MT. SAN JACINTO COMMUNITY COLLEGE DISTRICT

ADDENDUM NO. 2

BID NO. 2021-008

REBID OF SHADE STRUCTURES AT SAN JACINTO CAMPUS

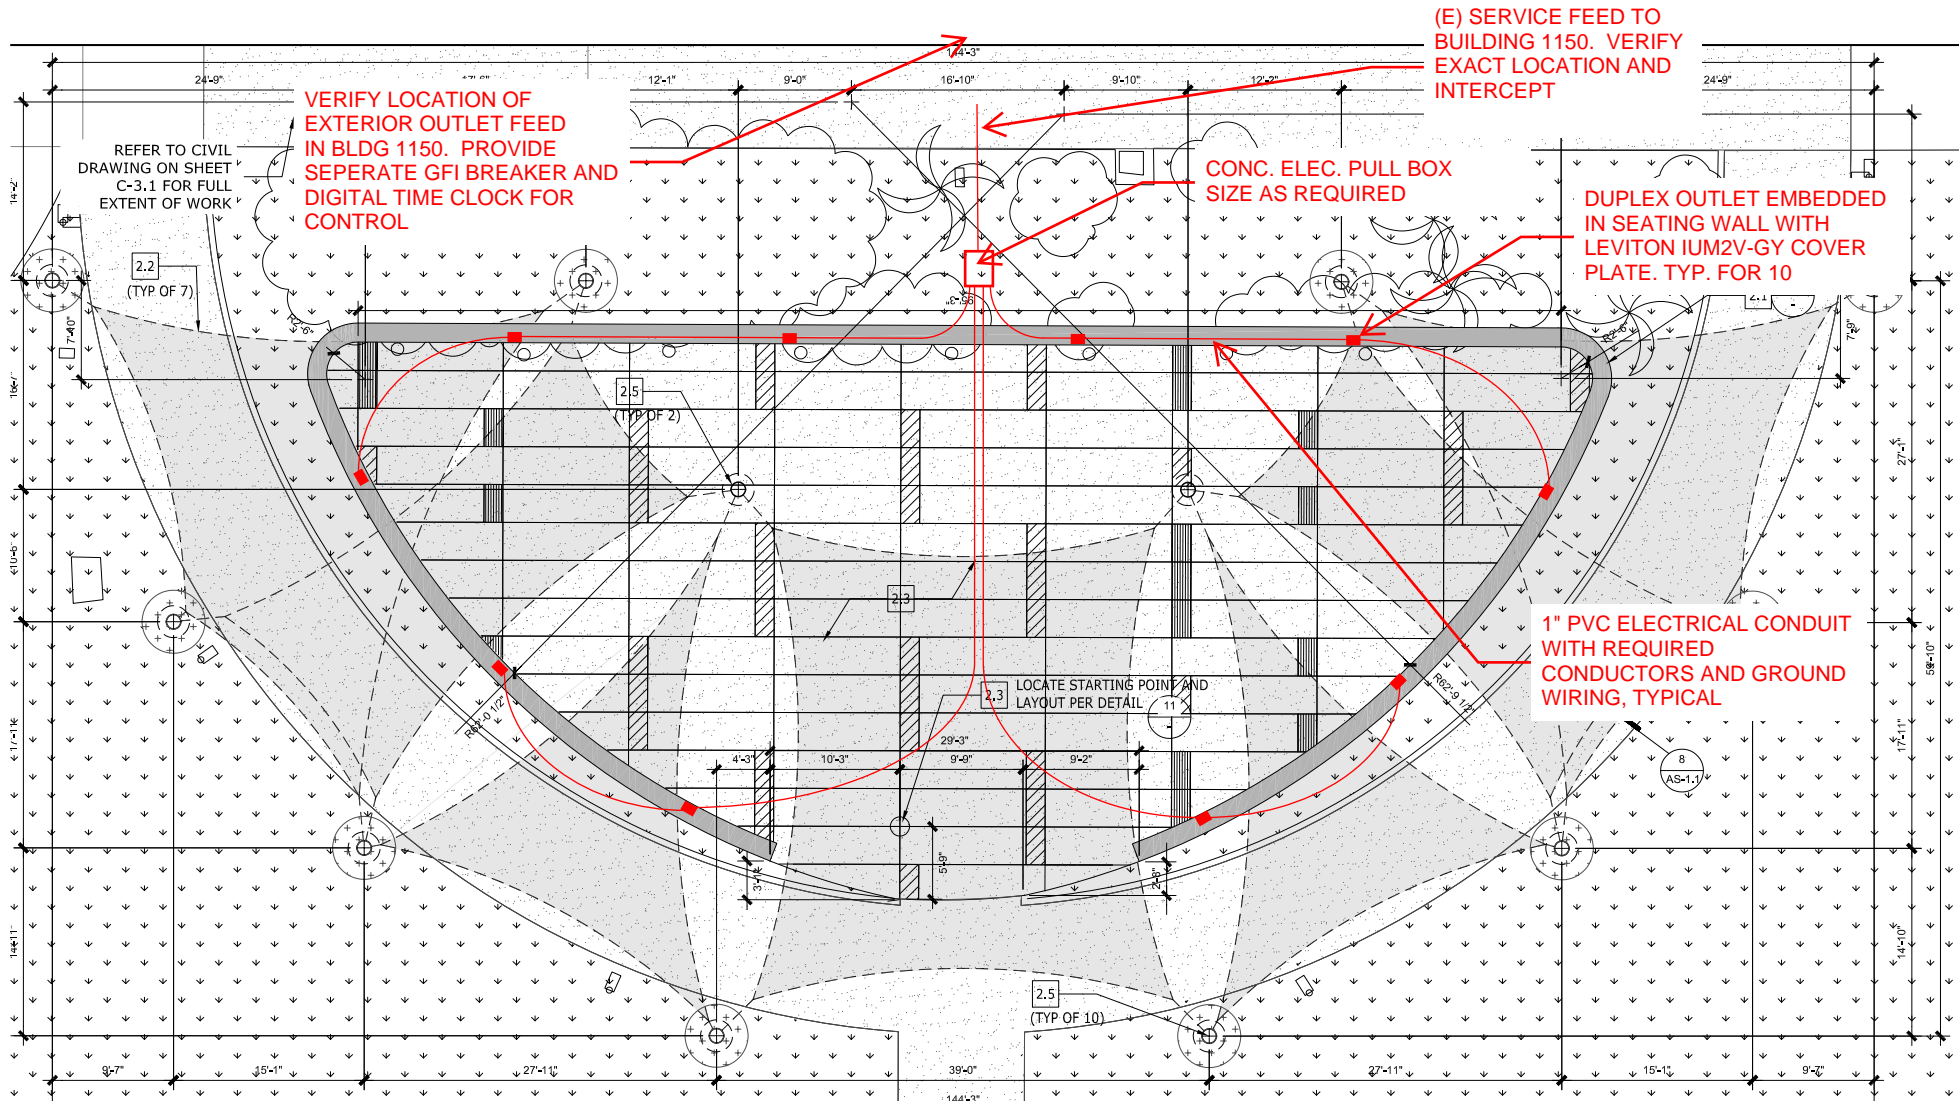
Item 1.2: Refer to Sheet AS-1.3, Details 5 and 20. Where reference to existing electrical outlets to remain, the contractor shall be required to remove outlets, conduits, and wiring and provide new exterior outlets per attached drawing CDR-01. Contractor shall provide all work required to re-establish outlets per revised drawing. Verify exact POC to existing electrical source in field. All work shall conform to the latest edition of the California Electrical Code (CEC).

(E) SERVICE FEED TO BUILDING 1150. VERIFY EXACT LOCATION AND INTERCEPT

VERIFY LOCATION OF EXTERIOR OUTLET FEED IN BLDG 1150. PROVIDE SEPERATE GFI BREAKER AND DIGITAL TIME CLOCK FOR CONTROL

CONC. ELEC. PULL BOX SIZE AS REQUIRED

DUPLEX OUTLET EMBEDDED IN SEATING WALL WITH LEVITON IUM2V-GY COVER PLATE. TYP. FOR 10

1" PVC ELECTRICAL CONDUIT WITH REQUIRED CONDUCTORS AND GROUND WIRING, TYPICAL
